NUCLEAR ENERGY INSTITUTE

SUBJECT: *Federal Register* Notice 69 FR 11464, March 10, 2004, Workshop to Discuss Combined License Topic COL-10, 10 CFR Part 52, Subpart C, Emergency Planning Inspections, Tests, Analyses and Acceptance Criteria (ITAAC)

Enclosure to NEI's May 27, 2004 Comments on EP ITAAC Workshop and EP ITAAC Proposals

Figure 1: PART 52 PROCESS FOR EMERGENCY PLANNING

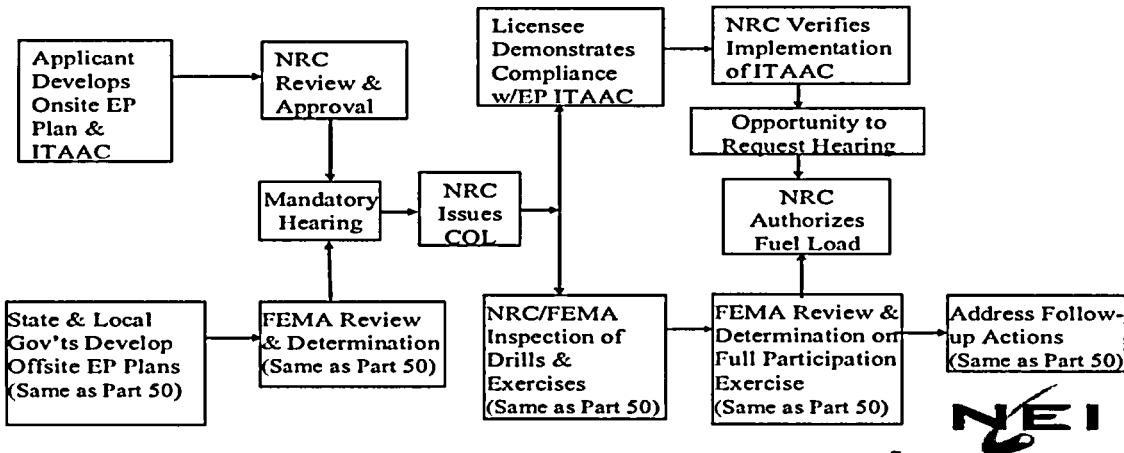
At the April 27 workshop, the industry presented Figure 1 to underscore certain key points. First, Figure 1 depicts that for plants licensed under Part 52; FEMA will review and make determinations on development and implementation of offsite emergency response plans by state and local organizations in the same way as it

has for plants licensed under Part 50. NRC will do likewise for the on-site EP elements by the licensee and will consider the offsite determinations by FEMA when making overall EP determinations required prior to COL issuance and prior to fuel load.

In addition to the normal inspections, evaluations and determinations by FEMA and the NRC, Part 52 licensees must also satisfy EP ITAAC established in the license, and the NRC staff must verify prior to fuel load that all ITAAC have been satisfactorily completed. As shown in Figure 1 and consistent with the principles outlined above, EP ITAAC should focus solely on significant on-site EP elements and offsite interfaces.

Figure 1 also highlights that FEMA will provide its determinations to NRC as it always has on the adequacy of offsite emergency plans (prior to COL issuance) and on the full participation exercise (prior to fuel load authorization).

Acceptance criteria for certain EP ITAAC will likely be shown to be met during conduct of drills and exercises, including the required full participation exercise. Figure 1 shows that results from NRC and FEMA inspections of drills and exercises may provide part of the basis for licensee ITAAC conclusions that EP ITAAC have been met. For example, FEMA may provide input regarding a test of the licensee's interfaces with offsite emergency responders.
